Technical Bulletin

60 16 03 February 25, 2016 **2043031** Supersedes Technical Bulletin V601602 dated February 5, 2016 to update damage code in warranty table.

Rattle or Creaking Noise from Panoramic Sunroof

Figure 1) Area to apply the self-adhesive film (glass panel removed for illustration purposes).

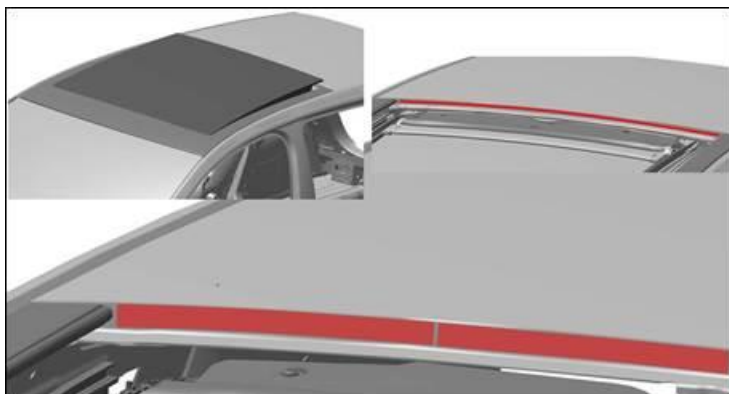
A rattle or creaking noise may be heard from the rear of the Panoramic Sunroof when driving on uneven roads with the sunroof closed.

Rattle or creaking noise is caused by the relative movement between the glass panel seal and body when the sunroof is closed.

- Cut the protective film sheet (part number AKL 448 300 04) into 3 strips 12 mm wide x 290 mm (290 mm is the length of the long side of the protective film sheet).
- Move the glass panel to the tilt open position.
- Thoroughly clean the contact area between the rear glass panel seal and the body.
- Apply the self-adhesive protective film strip to the body (Figure 1, in red).
- Close the glass panel.
